[PDF] 12.4.25 Planning Commission Comments - MGP

**Re: Proposed General Plan and Zoning Code Amendments Relating to Capitola Mall;
December 4, 2025, Planning Commission Item 6.C**

**Comments on Chapter 17.24 (“Commercial and Industrial Zoning Districts”) and 17.57
 (“Objective Standards for Mall Redevelopment”)**

Figure 17.57-1: Pedestrian Realm

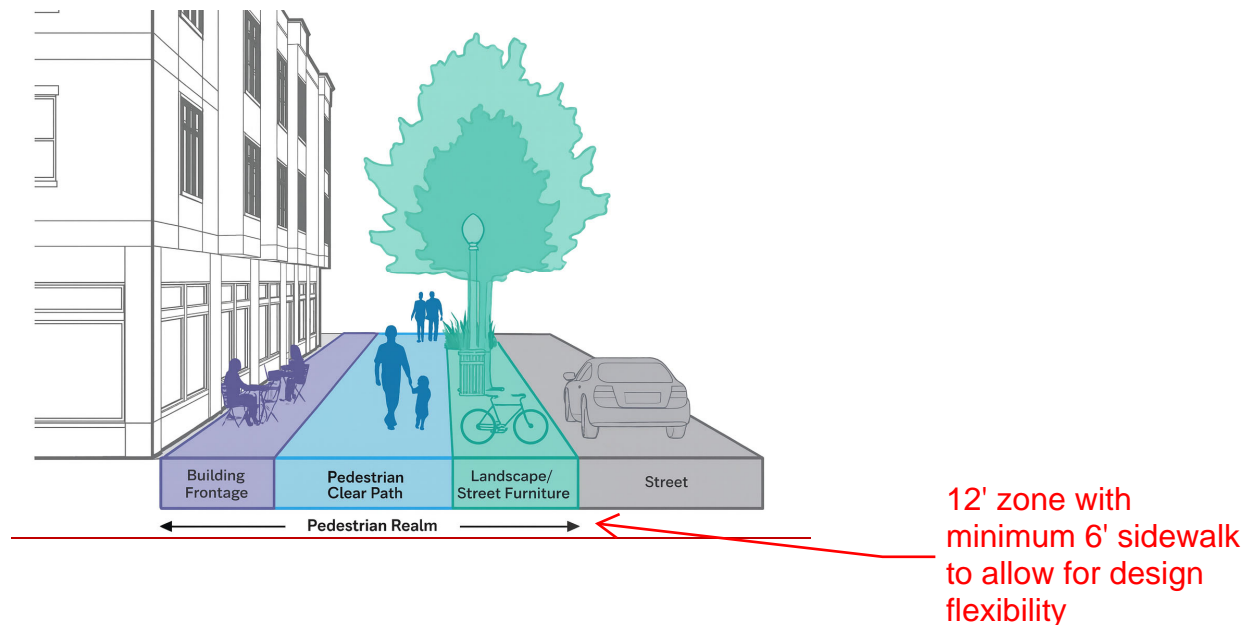
12' total with minimum 6ft Pedestrian Clean Path

Need design flexibility based on the design guidelines
